Appl. No. : **10/728,063**
Filed : **December 4, 2003**

REMARKS

Annotated Marked-up
Drawings in Reply to
Office Action of
January 31, 2005

**OPERATIONAL CONTROL DEVICE FOR JET PROPULSION
WATERCRAFT**
Tani et al.
Appl. No.: 10/728,063 Atty Docket: FY.50763USOA

Figure 2

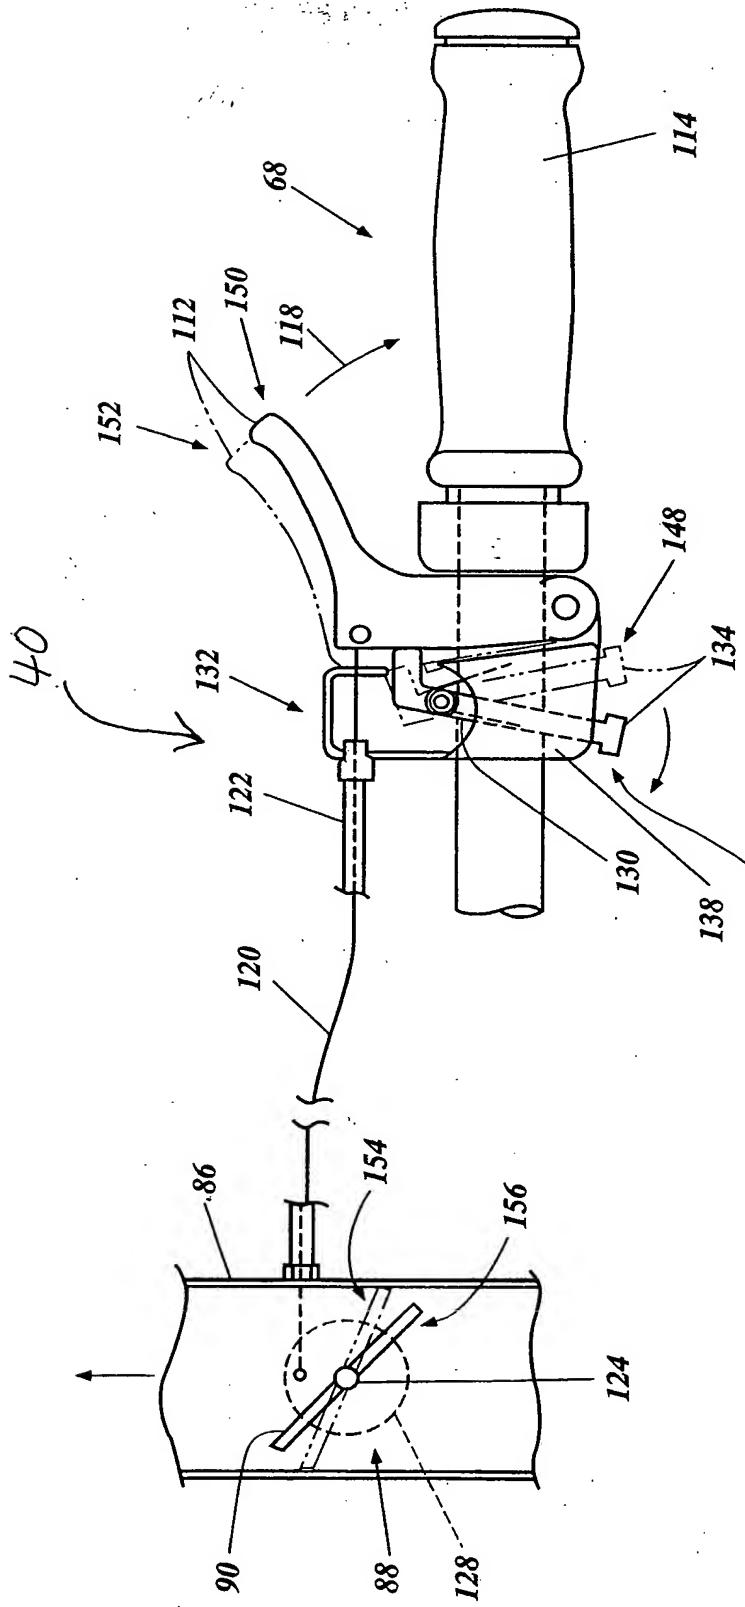
The Examiner objected to the drawings under 37 CFR 1.83(a) as not showing every feature specified in the claims. Specifically, the Examiner stated that the water diverter bucket of Claim 2 and the electric motor of Claim 14 were not shown. Applicants have canceled Claim 2, and thus, the present objection to Claim 2 is now moot.

The Examiner objected to the drawings under 37 CFR 1.84(p)(5) as not including reference numeral 40 mentioned in the description. Applicants submit herewith an amended drawing sheet in compliance with 37 CFR 1.121(d) including reference numeral 40 (see Figure 2). Accordingly, Applicants respectfully request that the Examiner withdraw this objection.

Applicants have amended Figure 2 and added Figure 2b as shown on the attached drawing sheets. These drawing sheets include a "Replacement Sheet" and a marked up version showing the changes to Figure 2 in red ink. Additionally, new Figure 2b is submitted on an additional separate sheet. As fully explained below, Applicants respectfully assert that these drawing changes are fully supported by the originally filed specification and claims, and therefore do not constitute new matter.

Applicants submit herewith a new drawing sheet in compliance with 37 CFR 1.121(d) including new Figure 2b. Figure 2b illustrates, schematically, an electric motor M that controls the throttle body assembly 88 through a direct connection 89. Applicants respectfully assert that new Figure 2b is fully supported by the originally filed specification and claims, and therefore does not constitute new matter. For example, original paragraph 38 recited that "The throttling mechanism can be controlled by an electric motor either through a direct connection or through a remote connection."
